ECE/TRANS/WP.29/GRE/2009/41  
17 July 2009

**COLLECTIVE AMENDMENTS**

Regulations Nos. 7 and 48

Proposal for Supplement 17 to the 02 series of amendments to Regulation No. 7

"FRONT AND REAR POSITION LAMPS, END-OUTLINE MARKER LAMPS AND STOP-LAMPS: MINIMUM ANGLES REQUIRED FOR LIGHT DISTRIBUTION IN SPACE OF THESE LAMPS 1/

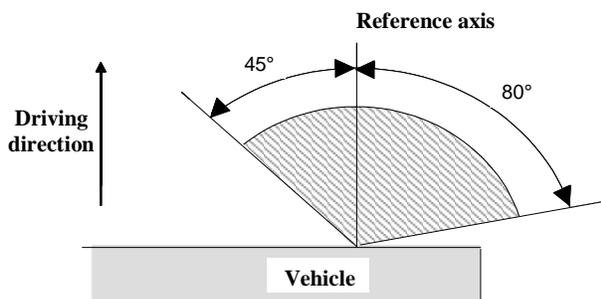
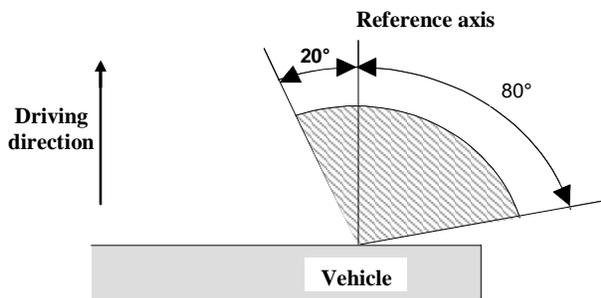
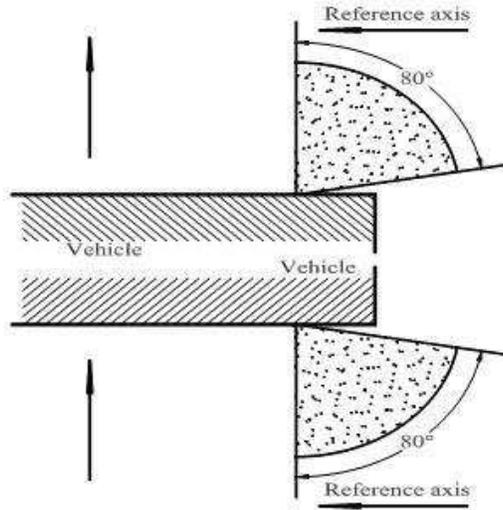
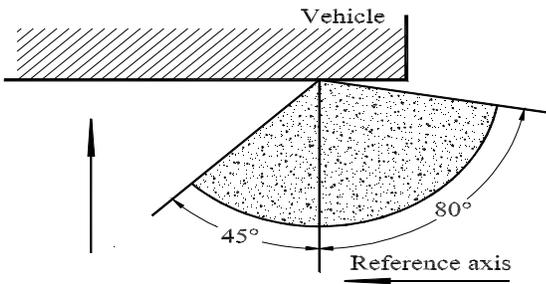
Annex 1, amend to read:

**Front End-outline marker lamp**  
**(AM)**

**Rear End-outline marker lamp**  
**(RM1, RM2)**
